Access Compliance Report Public Rights-of-Way (Curb Ramps)

Main Street: RIATA_ST Cross Street: PYLE_WAY Location: NE

ADA ID: RPRK220203122948 Ramp Type: Type 4 - Parallel Initial Pass/Fail: Fail Overall Compliance: No Severity Score: 2

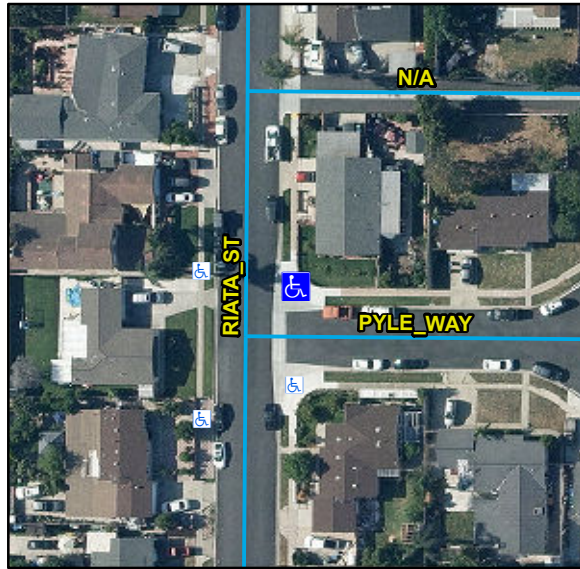
Compliance	Description	Data	Compliance	Description	Data
N/A	Ramp Length LT (in)	78	N/A	Ramp Length RT (in)	73
Yes	Ramp Width LT (in)	116	Yes	Ramp Width RT (in)	116
Yes	Ramp Run Slope LT (%)	4.6	Yes	Ramp Run Slope RT (%)	4.7
No	Ramp Cross Slope LT (%)	2.8	Yes	Ramp Cross Slope RT (%)	1.3
N/A	Landing Present	N/A	N/A	DWS Provided	N/A
N/A	Landing Length (in)	N/A	N/A	DWS Contrast	N/A
N/A	Landing Width (in)	N/A	N/A	DWS Length (in)	N/A
N/A	Landing Run Slope (%)	N/A	N/A	DWS Full Width	N/A
N/A	Landing Cross Slope (%)	N/A		DWS Offset Type	N/A
N/A	Landing Movement Obstructed?	N/A	N/A	DWS Offset Left (in)	N/A
	Landing Movement Type	N/A	N/A	DWS Offset Right (in)	N/A
N/A	Landing Shared	N/A			
N/A	Clear Space	Yes			
N/A	Clear Space To Crosswalk (in)	N/A			
N/A	Marked Crosswalk 1	No	N/A	Marked Crosswalk 2	No
	Crossing 1 Direction	W		Crossing 2 Direction	S
	Marked Crosswalk 1 Width (in)	N/A		Marked Crosswalk 2 Width (in)	N/A

Remove & Replace Curb Ramp With Two New Directional Ramps or Equivalent.
